DC2 Provision Comparison

SCHEDULE “B”

(DC2) SITE SPECIFIC DEVELOPMENT CONTROL PROVISION

Appendix 1 – Site Plan - Previous

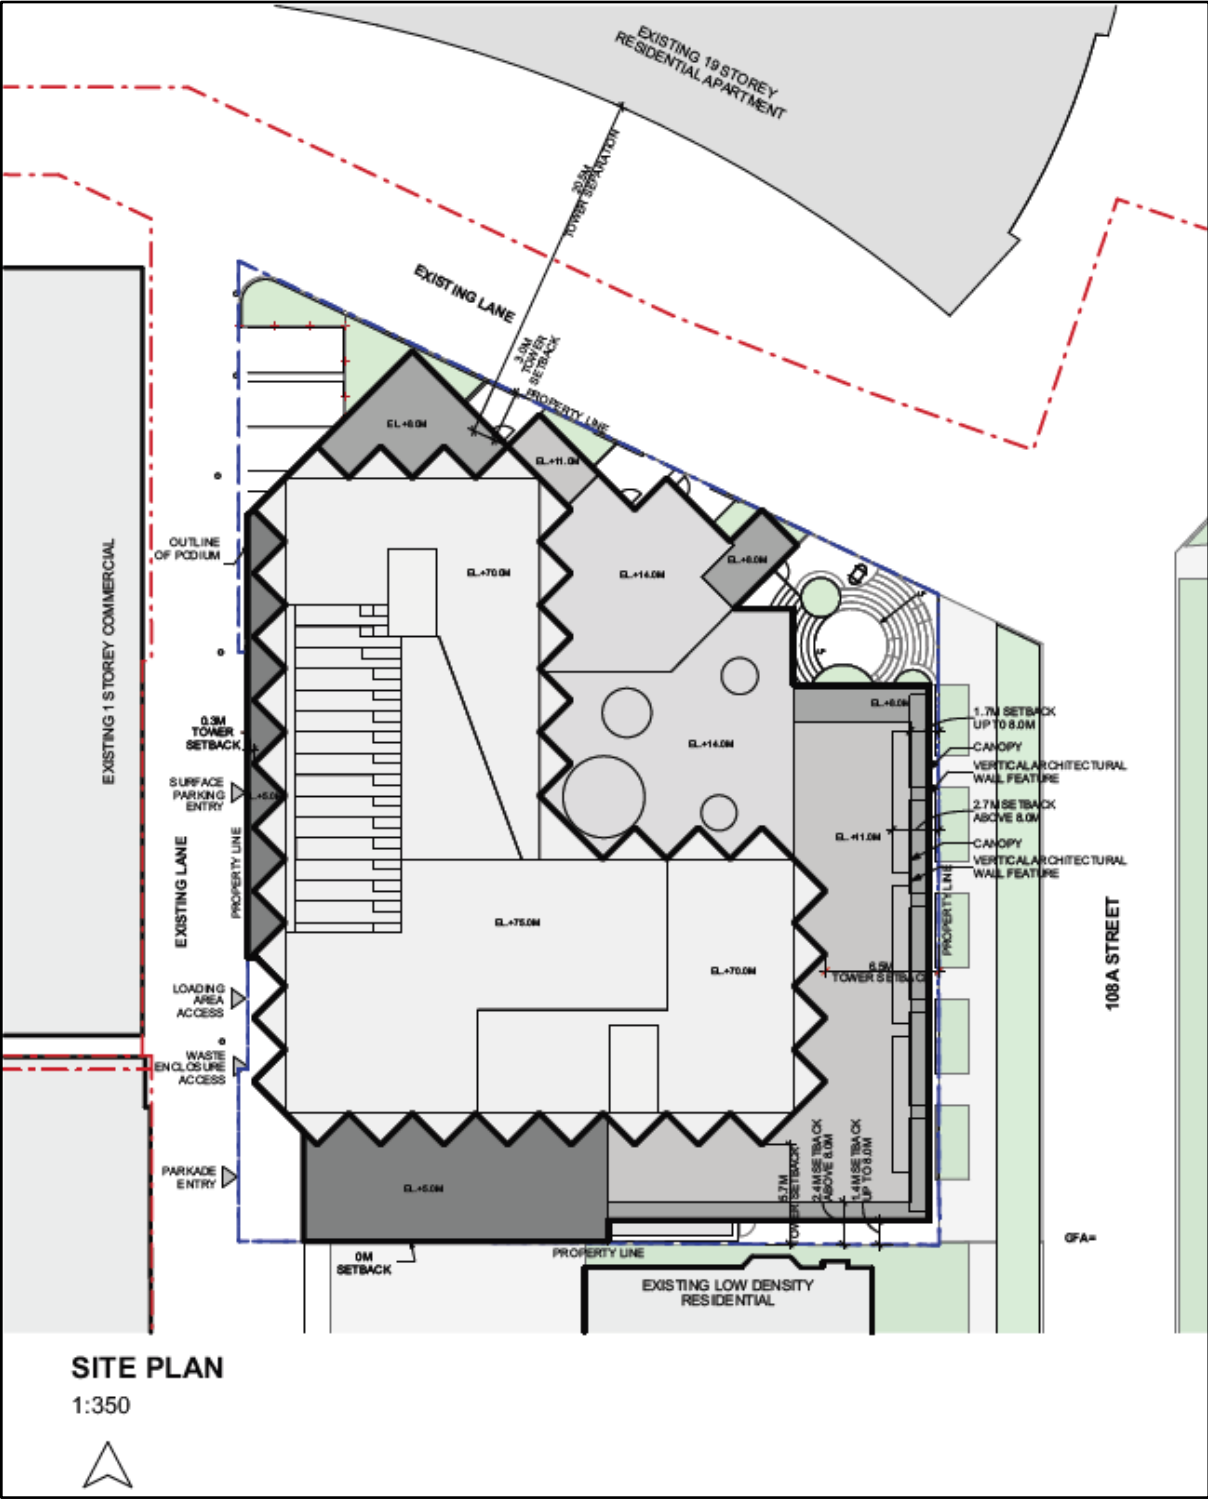
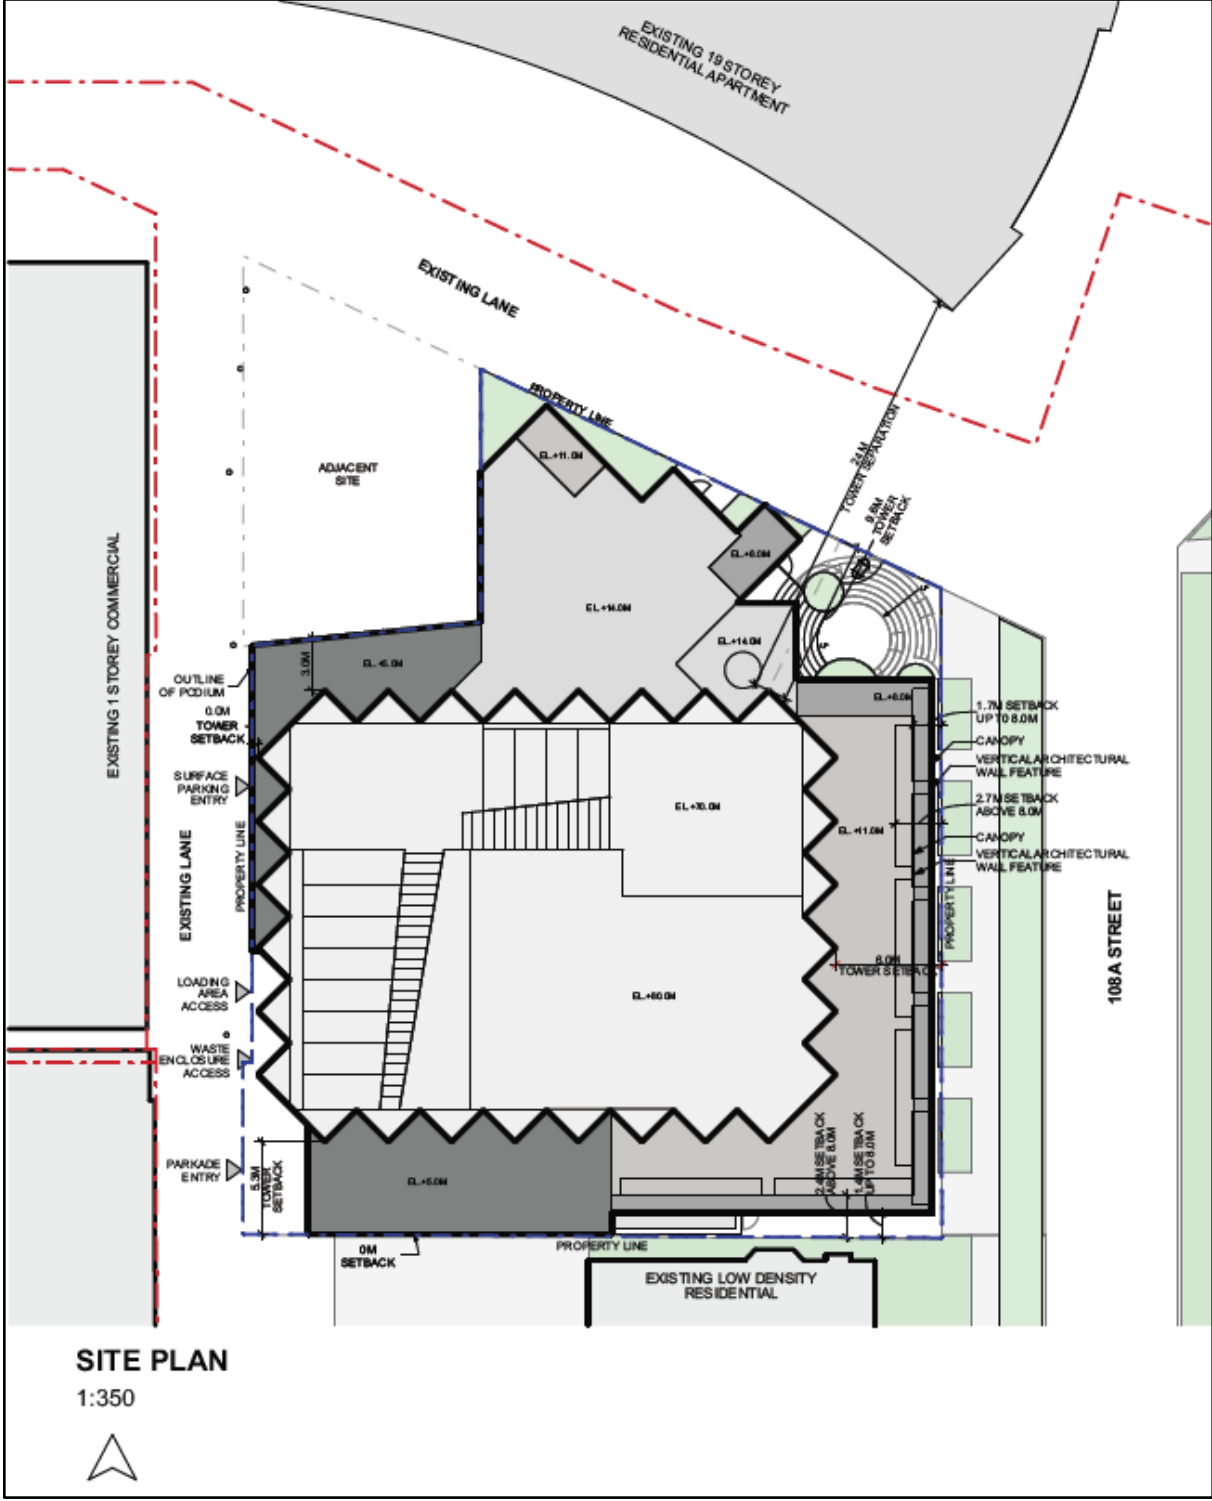
1. The development shall be in general conformance with the attached Appendices.
2. Building Height:
 - a. The maximum Height of the Tower shall vary between ~~70~~75.0 m and ~~75~~80.0 m, as shown on Appendix 1; and

- b. 3.0 m from the north Lot line, ~~except for the portion of the Tower within 18.0 m of the east Lot line where~~ abutting the minimum north Setback shall be 16. adjacent Site shown on Appendix 1 – Site Plan.

Appendix 6 – Landscape/Amenity Area Ground Concept – Previous

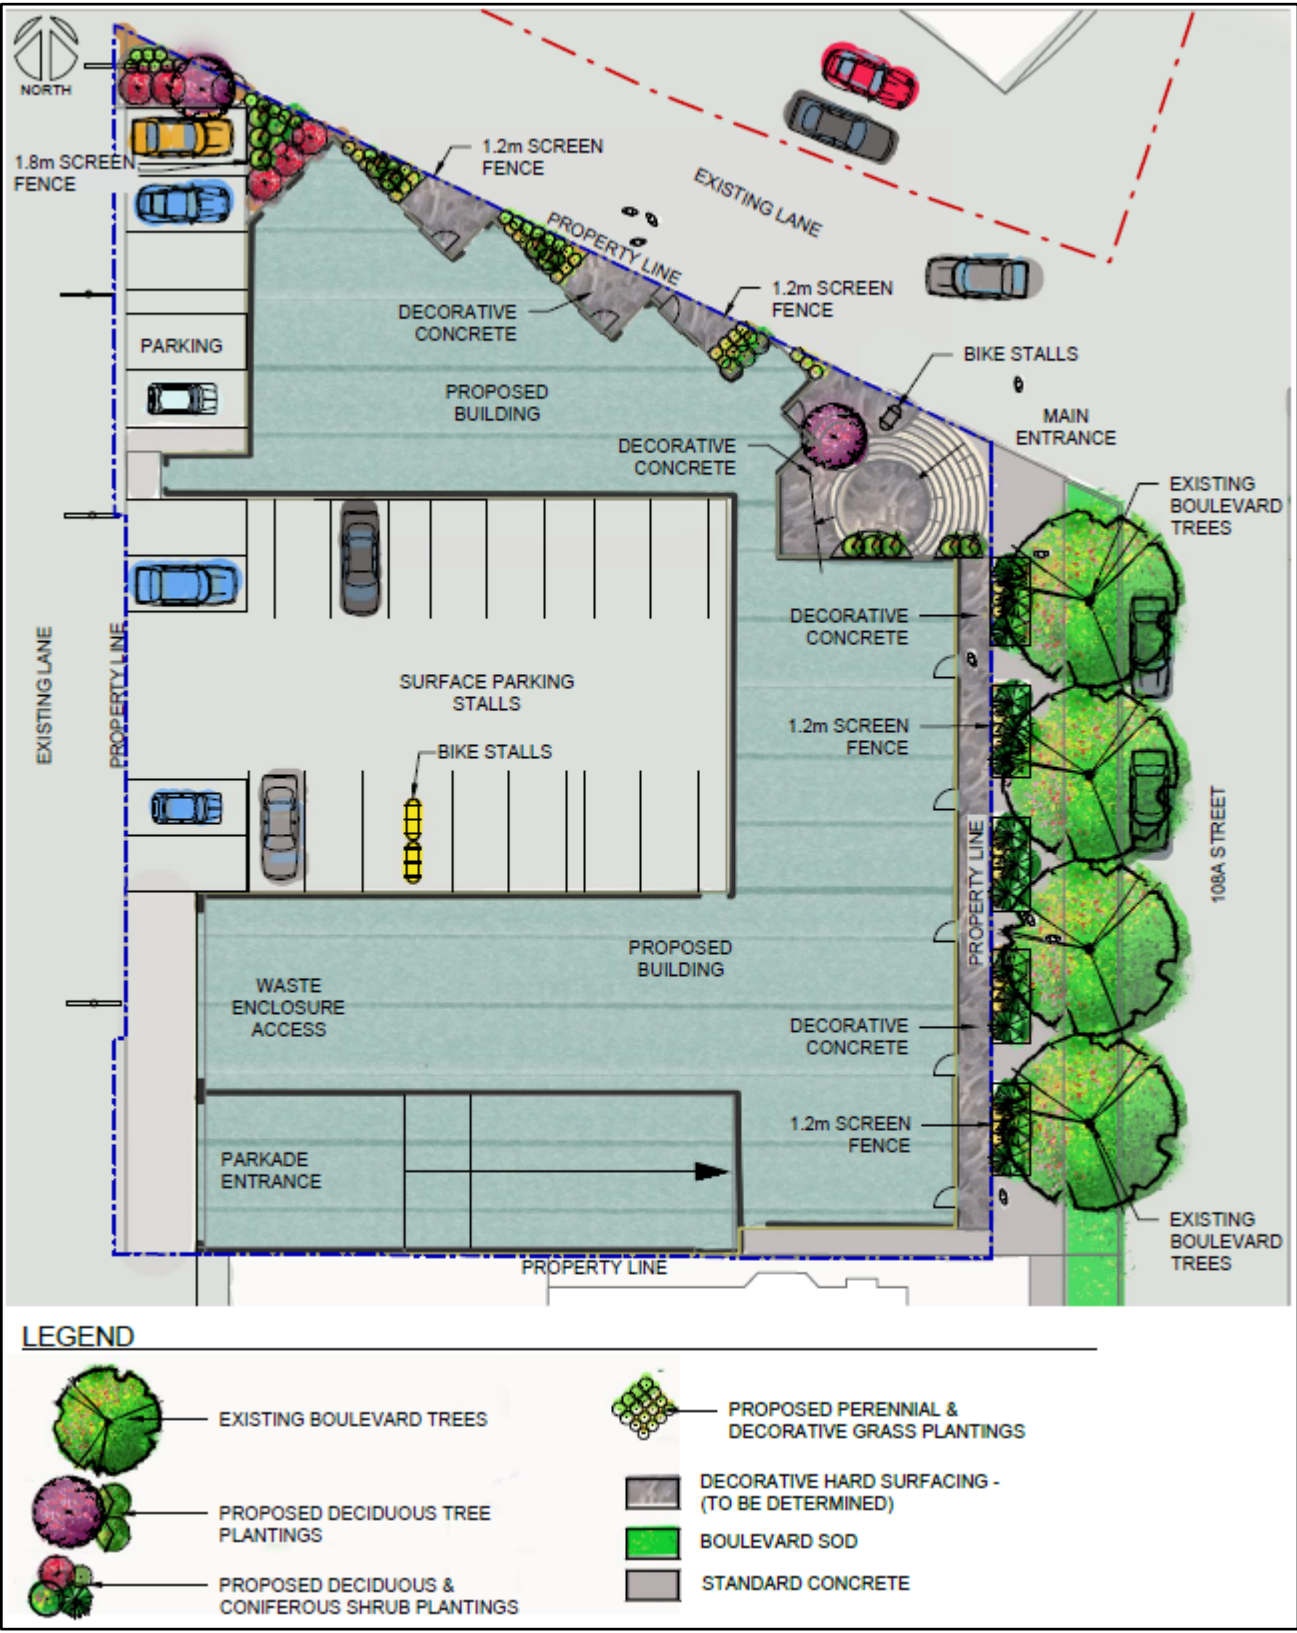
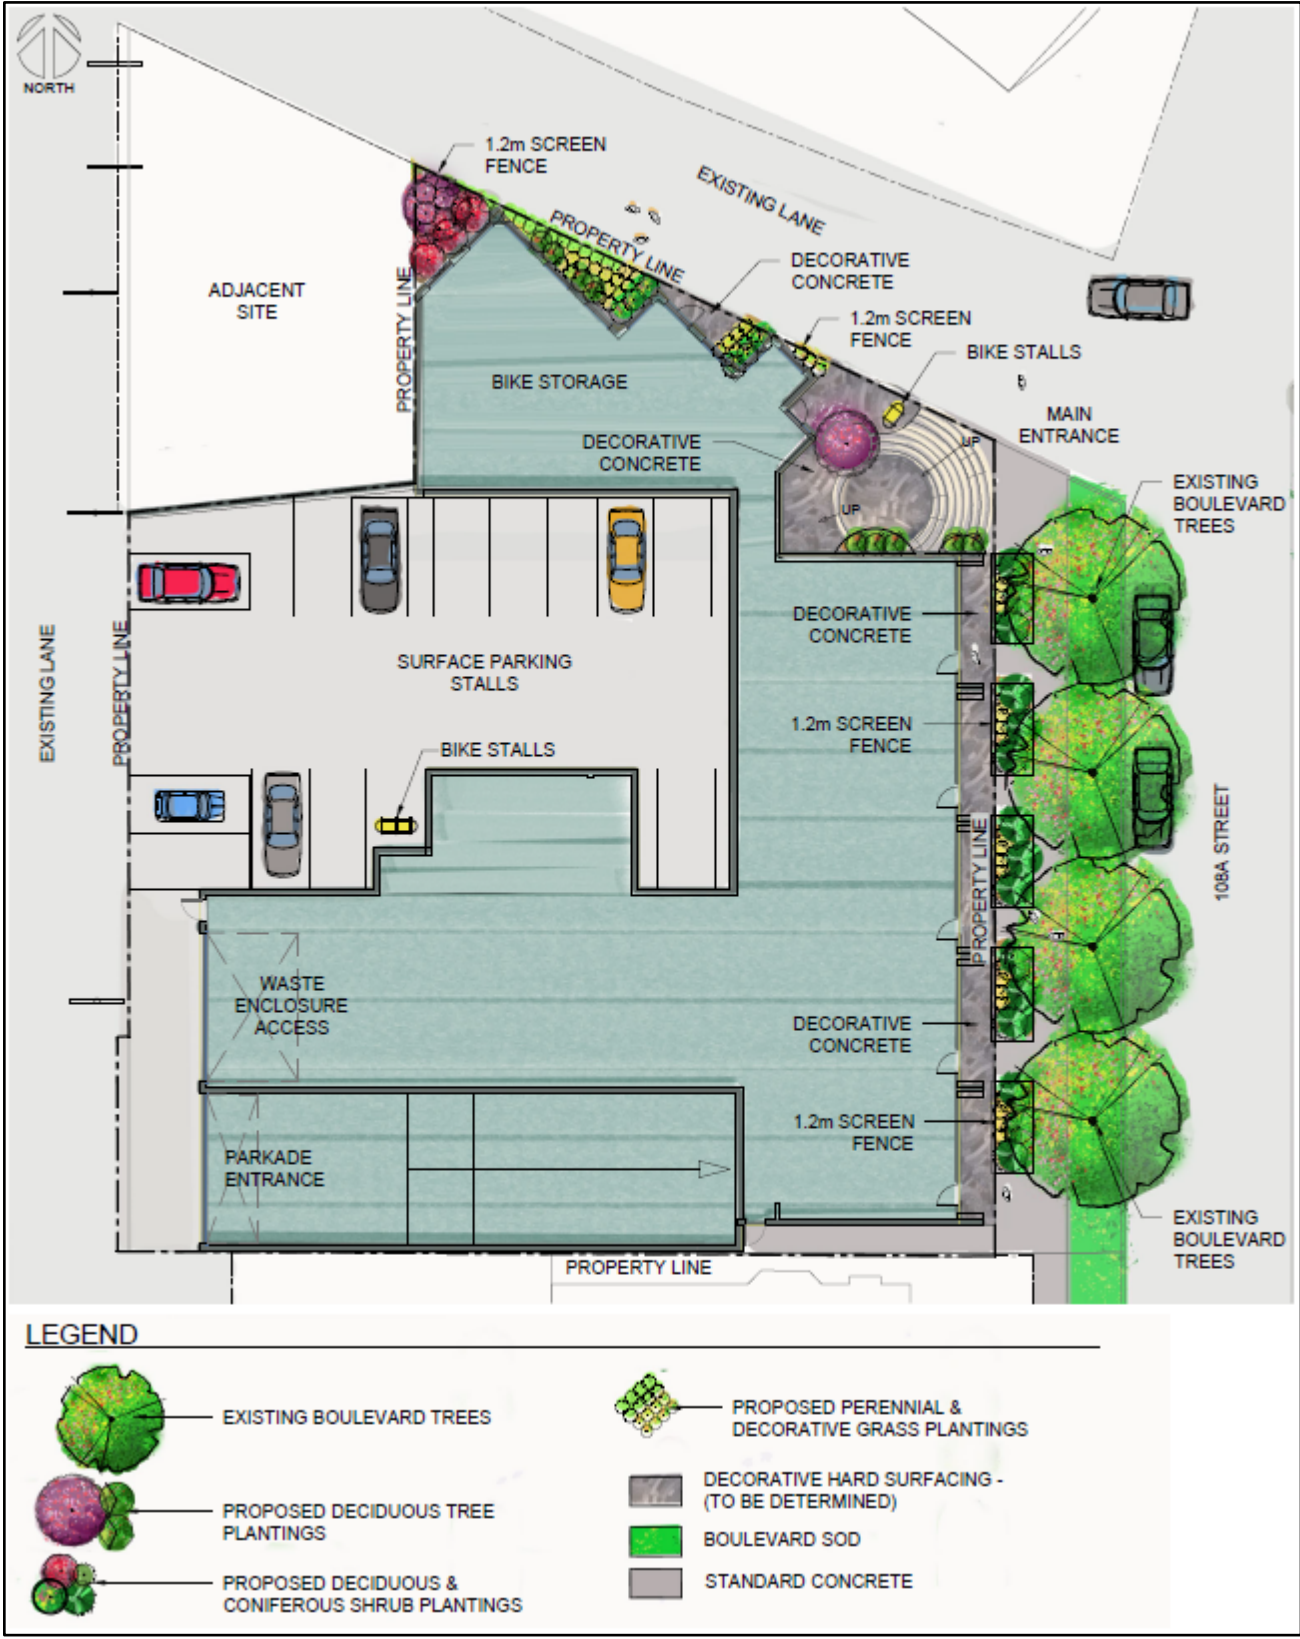
- b. Landscaping Plans shall incorporate native and/or drought tolerant species into the Landscaping design;
 - c. Setbacks from the ~~north and~~ east shall provide entry transitions including features such as steps, gates, hedges, low walls, for Dwellings fronting 108A Street NW ~~and the north Lane~~;
